Subject: Examination of the canopy lock

Effectivity: Glider K 8 , K 8 B , K 8 C

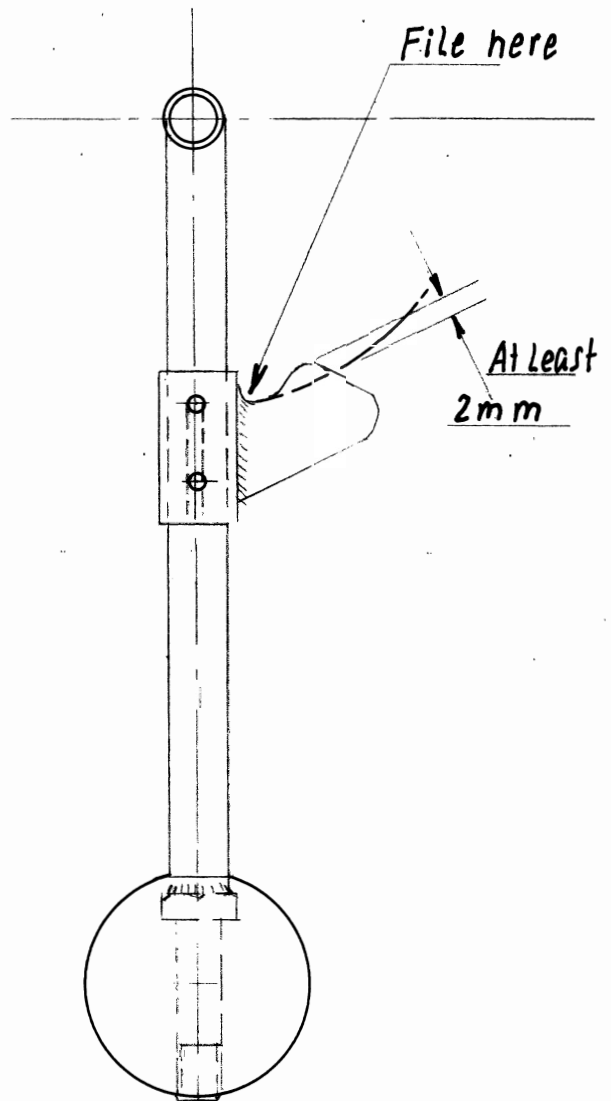
Instruction: The canopy lock has to be examined if the cam is at least 2 mm high.
 If not, take a file to make it deeper.
 Note the examination in the log book.
